SUBJECT: FORWARDS RESPONSES TO HYDROLOGY-METEOROLOGY BRANCH QUESTIONS
 Q372.2 & Q372.3 PER 790108 LTR.DESIGN INTERFACES BETWEEN
 RADWASTE REDUCTION & SOLIDIFICATION SYS ARE NOT COMPLETE.
 ACCIDENT ANALYSIS TO BE RECALCULATED.

Re: Nine Mile Point Unit 1
Docket No. 50-220
DPR-63

Question 372.2

Response 372.2

FIGURE 1

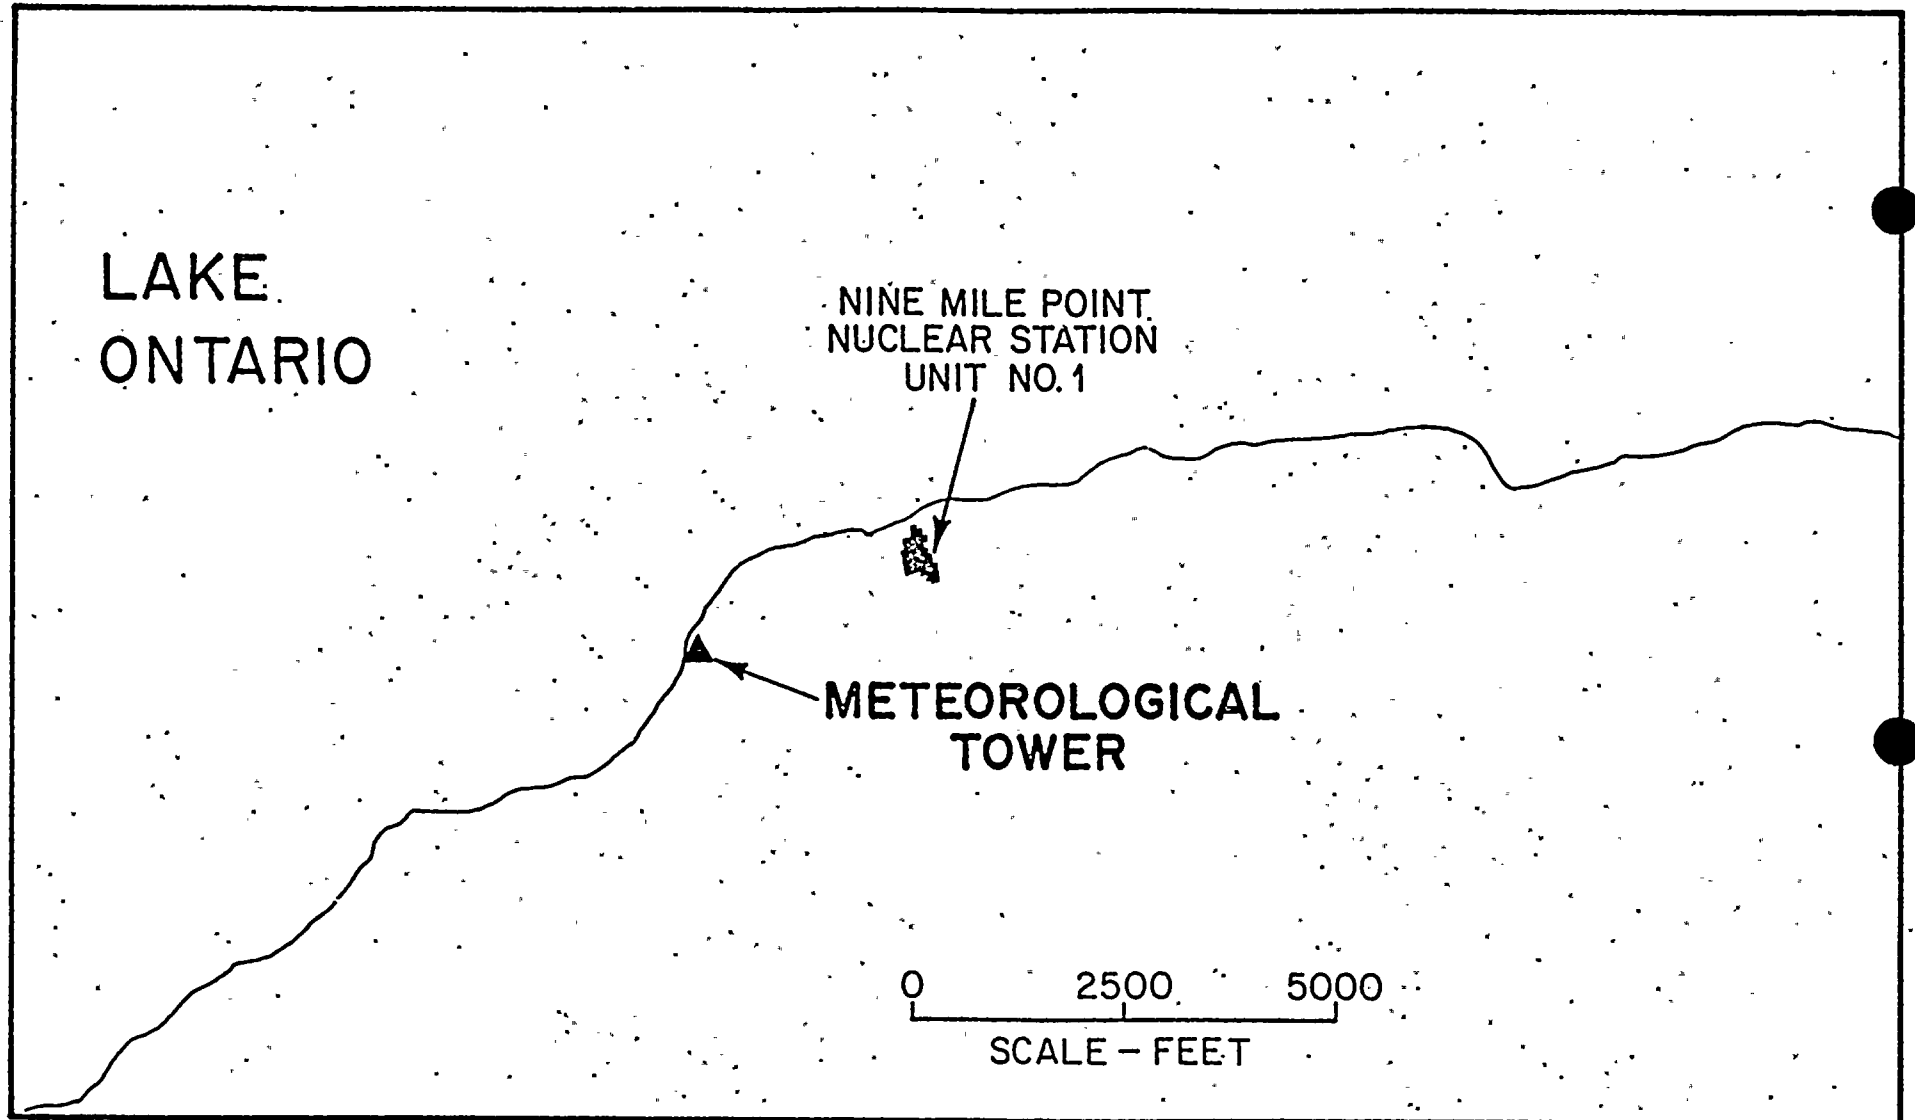
In your evaluation of the maximum credible accident, you used the model described in Regulatory Guide 1.3 and assumed an elevated release. As stated in Regulatory Guide 1.3, the guide's model should be used only until adequate site meteorological data are obtained. It is our position that you should either (1) provide relative concentration (X/Q) values based on site data for both elevated and ground-level releases for the maximum credible accident, or (2) justify that your FSAR or latest assessment of short-term diffusion estimates is conservative. If you undertake to justify your recent assessment, describe the atmospheric dispersion model which you have used to estimate X/Q values for the maximum credible accident. (Also see Question 372.3.) Provide (or reference) the meteorological data that you have used and justify that it is either representative of the air layers into which the effluents will be released or provides for a conservative assessment. Include a discussion on the marine-air/land-air transition as it relates to the meteorological tower data and the atmospheric diffusion model.

The location of the meteorological tower in relationship to the Nine Mile Point Nuclear Generating Station No. 1 is shown in Figure 1. The data collected at the tower are representative of the meteorological conditions under which effluents are released. The proximity of the 200 foot tower to the plant and the Lake Ontario shore assures that the data are representative of the conditions used in an accident evaluation, both at ground level and for an elevated release.

The tower was located with the marine-air/land-air transition zone in mind. As the tower is situated on the Lake Ontario shoreline, the data reflect the turbulence of the air from the direction from which the wind blows. Therefore, the transition from a stable case over the lake to an unstable case over the land has been accounted for in the diffusion model by conservatively assuming fumigation for the 2-hour accident X/Q for the stack. The reverse flow of stable air over the land flowing into unstable air over the water has also been treated conservatively by the 2-hour fumigation calculation.
